Re: One University Place Proposed Development

STAFF REPORT

Item: Preliminary PUD submittal
St. Andrew Presbyterian Church Site
1300 Melrose Avenue

Date: April 27, 2009,

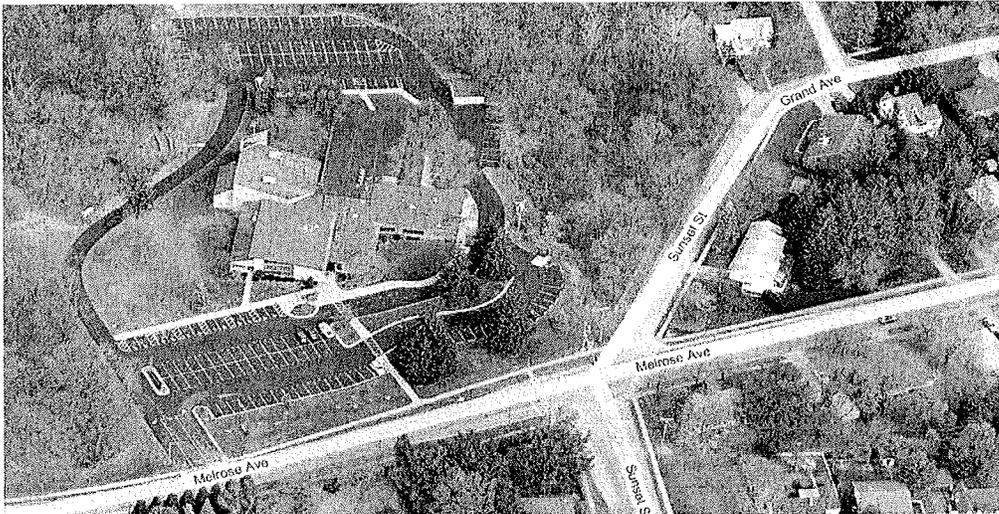
The preliminary PUD indicates that the proposed condo building at the rear of the building will have an overall height of 64' which is 29' taller than allowed by current zoning standards. To minimize the perceived mass of the building the developer has proposed a terraced flat roof design. The preliminary PUD indicates that the building would step-up from 4-6 stories on the east and 3-6 stories when viewed from the west. The Building Heights indicated in the PUD are measured from the first floor grade at the building entrances to the top of the roof. Elevations are based on aerial contour mapping (see attached graphic).
